# Product Change Notification

## 106303 - 00

**Change Notification #:** 106303 - 00  
**Change Title:** Intel NetStructure® MPCHC0001 14U Chassis, PCN 106303-00, Product Design, PEM, Fan Tray, and Packaging changes  
**Date of Publication:** May 11, 2006

### 1. Fan tray insulator

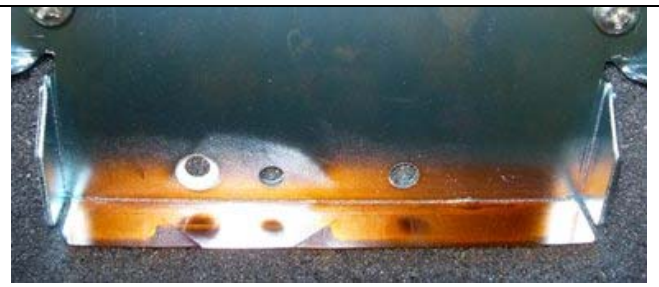
Adjust length of Insulator between fan tray board and top sheet metal to better fit.

Create another insulator to cover area currently being covered by Kapton tape on the front inside of the fan tray, as shown below.

Old – Kapton Tape

New – Kapton insulator
